PROPOSAL FOR DRAFT REVISION TO REGULATION No. 29 – DRAFT 03 SERIES OF  
AMENDMENTS

**UNIFORM PROVISIONS CONCERNING THE APPROVAL OF VEHICLES WITH  
REGARD TO THE PROTECTION OF THE OCCUPANTS OF THE CAB OF A  
COMMERCIAL VEHICLE**

Figure 1. Front impact test (test A)

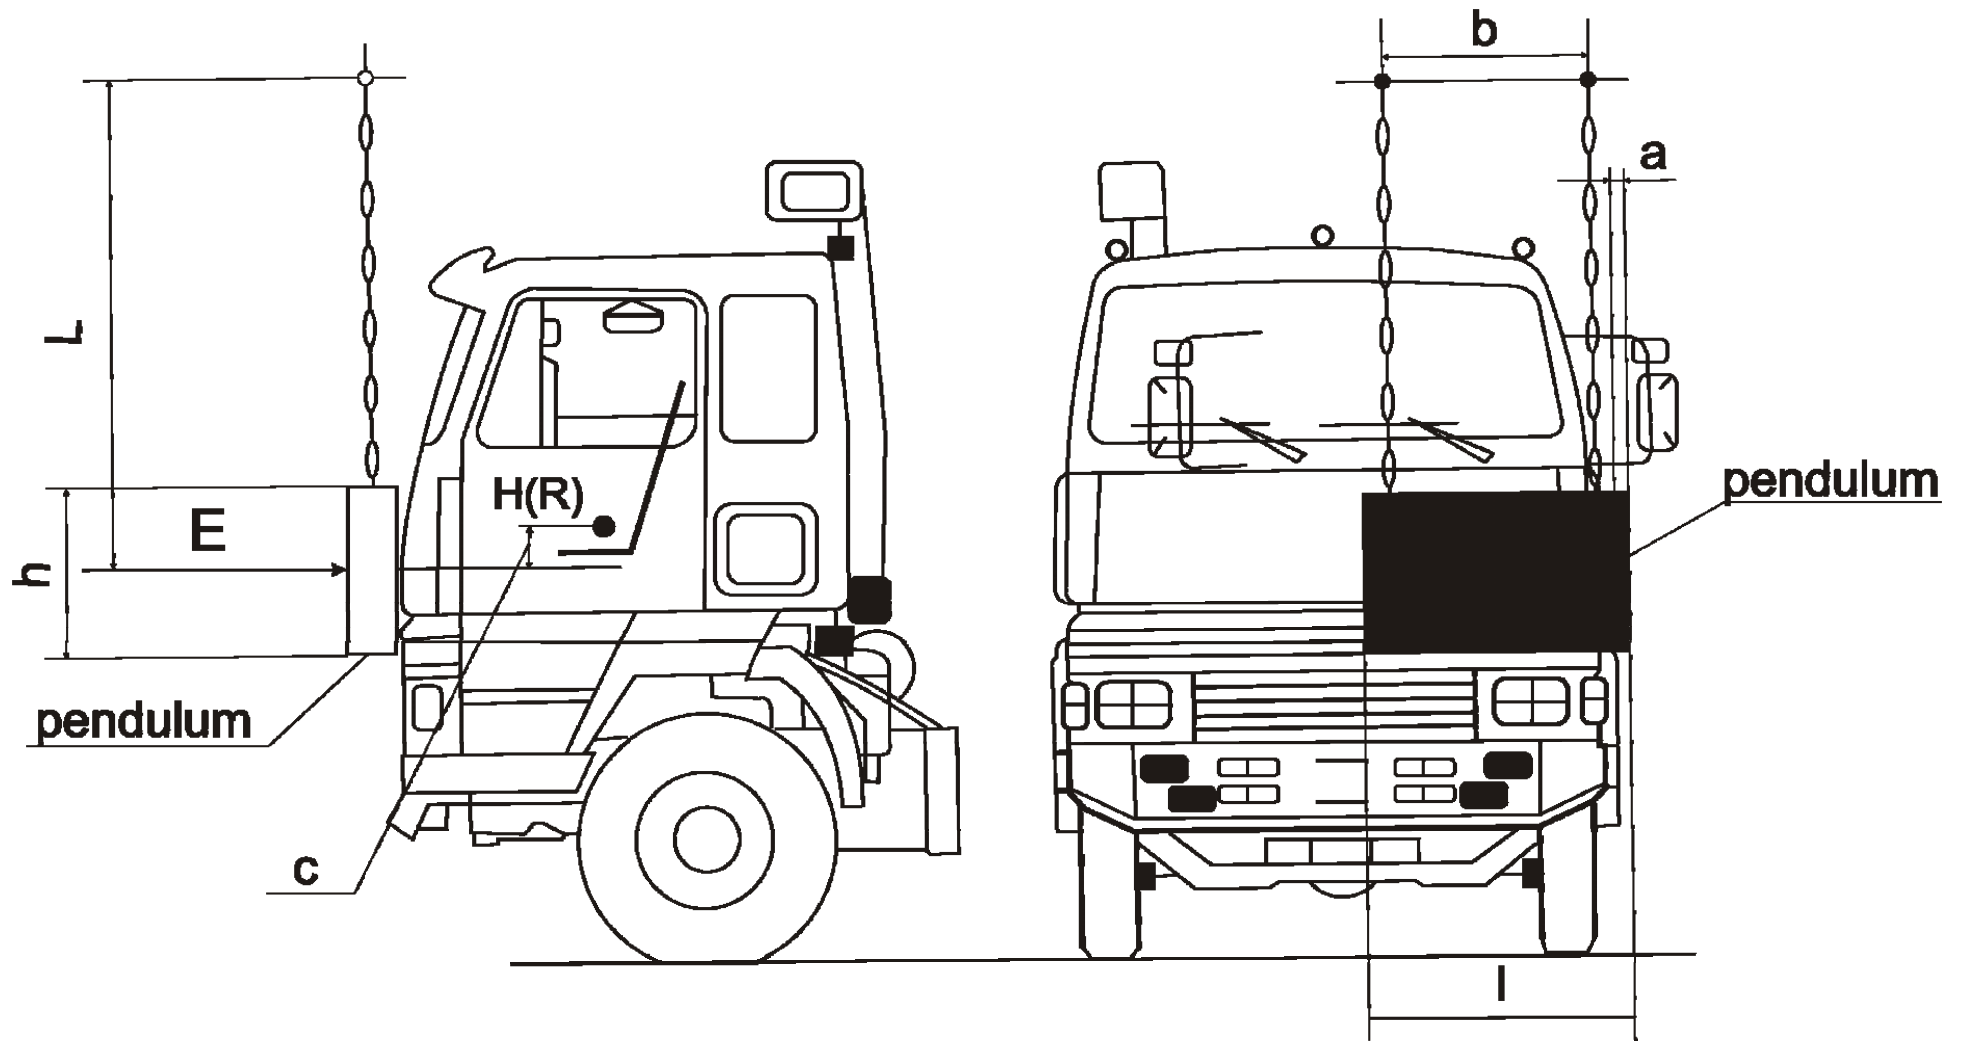
4.2.1. The swing-bob shall strike the cab at the front in the direction towards the rear of the cab. The direction of impact shall be horizontal and shall be parallel to the median longitudinal plane of the vehicle (figure 1). The impact energy shall be 40 kJ for vehicles of the category N<sub>2</sub> with permissible maximum mass over 7,500 kg and N<sub>3</sub>, 25 kJ for vehicles of the category N<sub>2</sub> with permissible maximum mass less than 7,500 kg and 15 kJ for vehicles of the category N<sub>1</sub>.

4.2.3. Test A need not be carried out for conventional trucks.

Figure 2. Roof strength (test B)

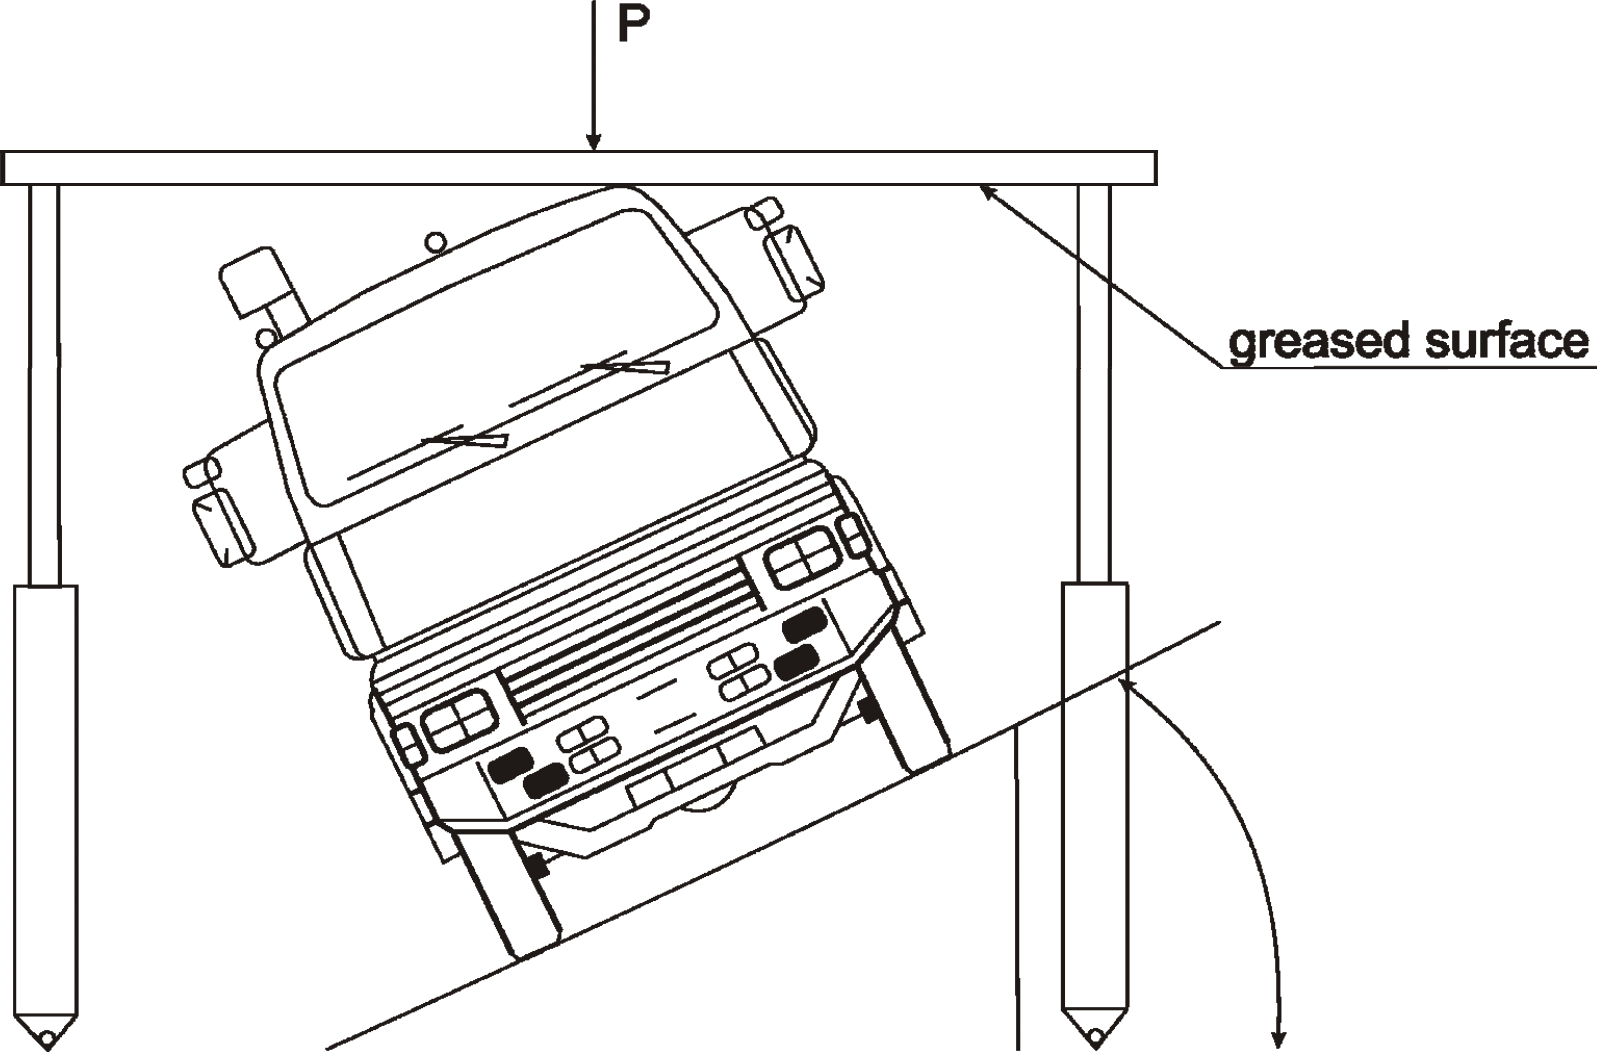
5.1.1. The cab shall be angled to 25 degrees in relation to its longitudinal axis. A driver's side of the cab shall be higher than the other one (figure 2).

5.1.3. The roof of the cab shall withstand static load (P). The load shall be measured by the following expression:

$$P=[K] P_{CH}$$

in which: P<sub>CH</sub> – weight of a vehicle in running order, on forward axis; K – coefficient of dynamic load equal 2,5. The maximum load the roof of the cab shall withstand shall be not more than 10 t.

Figure 3. Rear-wall strength (test C)

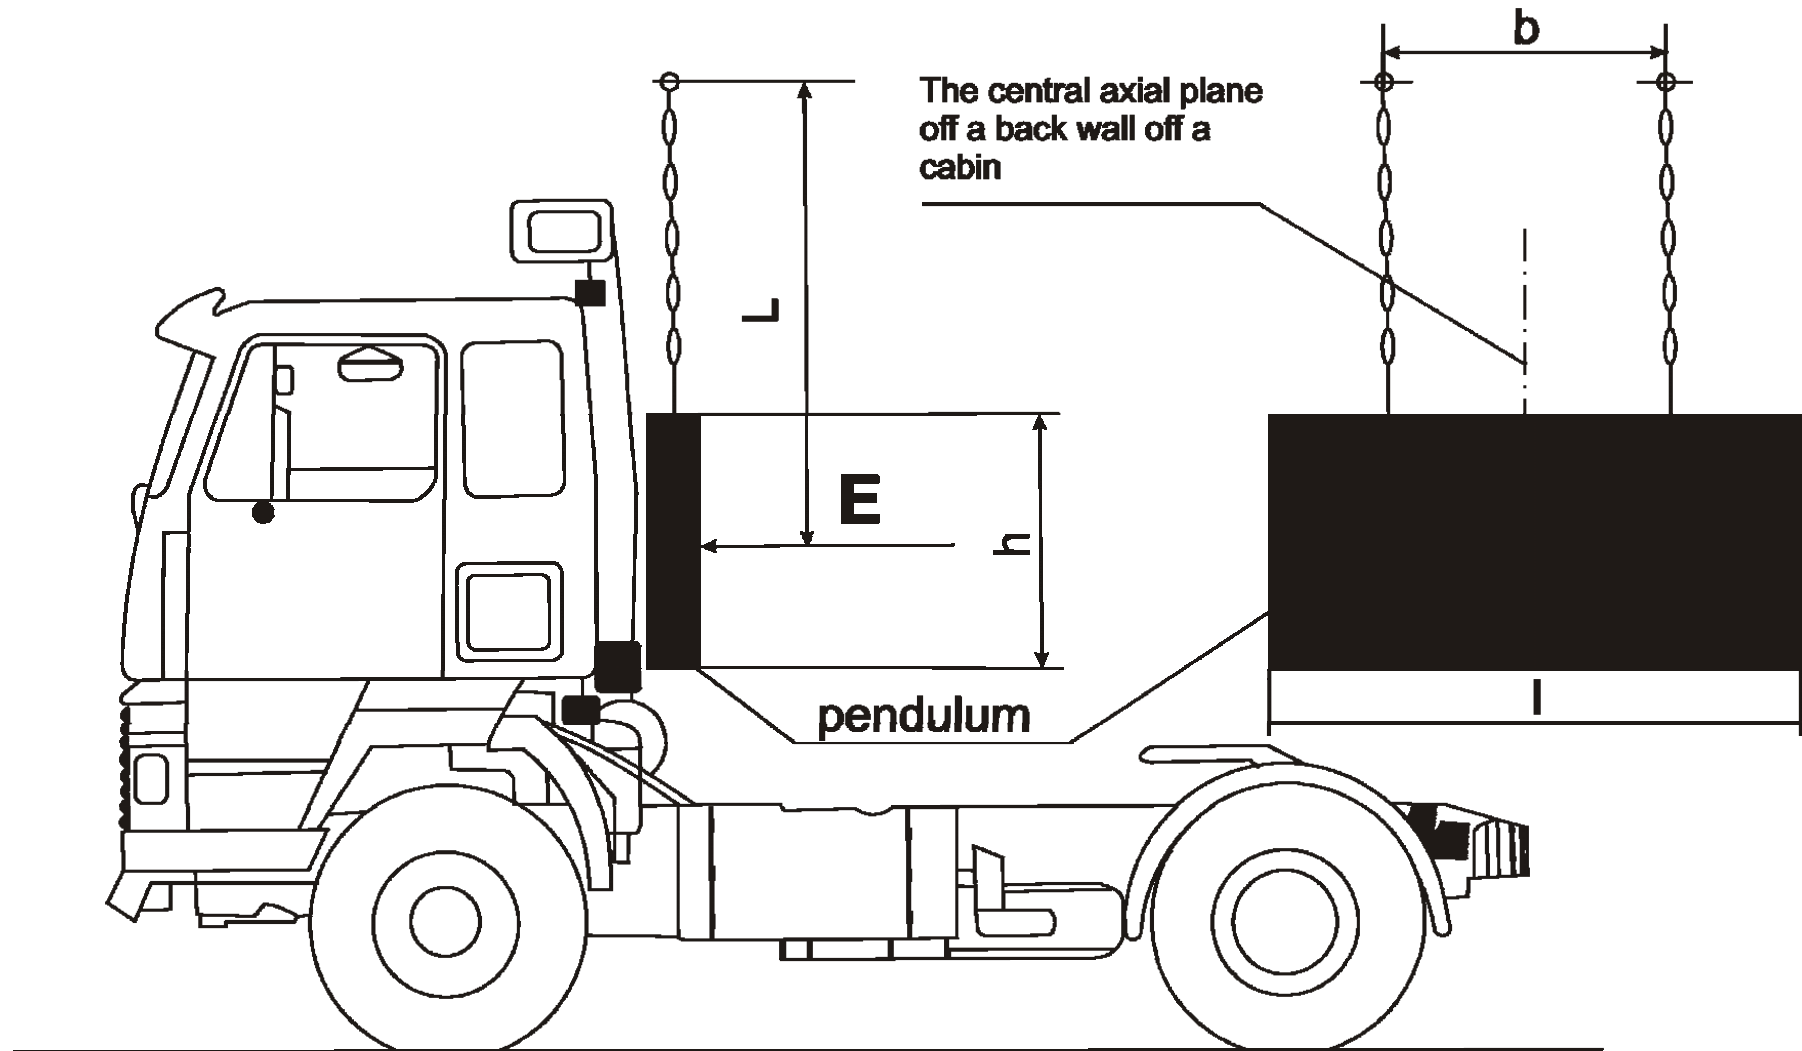
- 6.2.1. The swing-bob shall strike the cab at the rear in the direction towards the front of the cab (figure 3). The direction of impact shall be horizontal and shall be parallel to the median longitudinal plane of the vehicle. The center of the impact shall match the central axial plane of the rear side of the cab and shall be situated in the centre of the rear between the roof and the floor of the cab. The impact energy shall be 40 kJ for vehicles of the category N<sub>2</sub> with permissible maximum mass over 7,500 kg and N<sub>3</sub>, 20 kJ for vehicles of the category N<sub>2</sub> with permissible maximum mass less than 7,500 kg and 10 kJ for vehicles of the category N<sub>1</sub>.**

- 6.2.2. Vehicles of the category N<sub>1</sub> can be tested by using a static load. The rear wall of the cab shall be capable of withstanding a static load of 4 kN per tone of permissible useful load. This load shall be applied by means of a rigid barrier perpendicular to the longitudinal median axis of the vehicle, covering at least the whole of the cab rear wall situated above the chassis frame, and moving parallel to that axis.**

Fig. 1

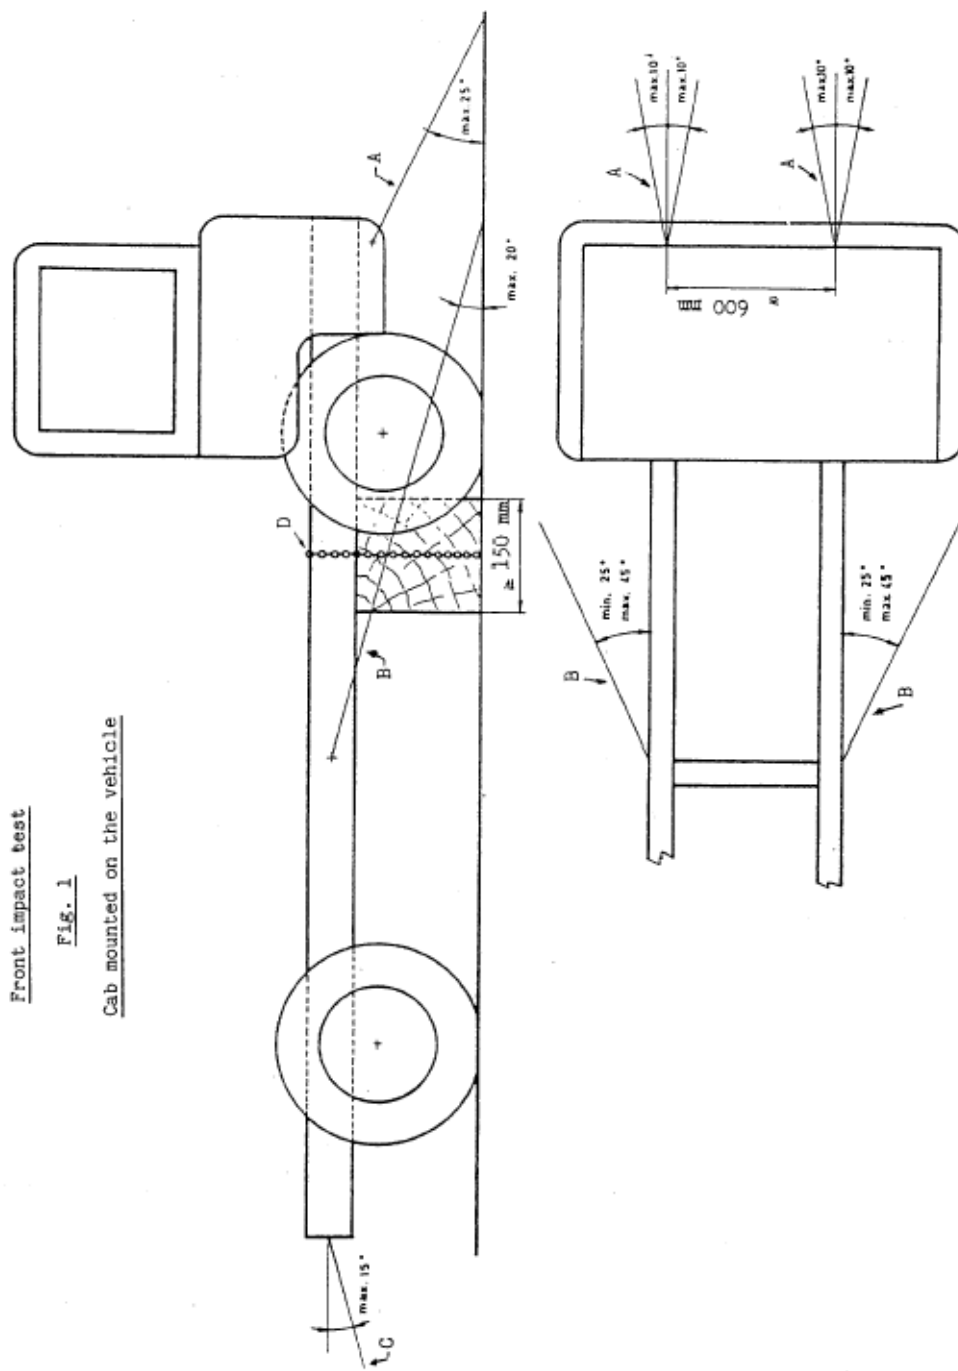
The chain or rope C shall to begin with be placed under a load of approximately **1 kN** ~~100 kgf~~. All slack in the four chains or ropes A and B shall then be taken up and chain or rope C shall be subjected to a tensile stress of not less than **10 kN** ~~1,000 kgf~~. The angle of chain or rope C with the horizontal shall not exceed 15°. A vertical

blocking force of not less than **500 N** ~~50 kgf~~ shall be applied at point D between the chassis frame and the ground.
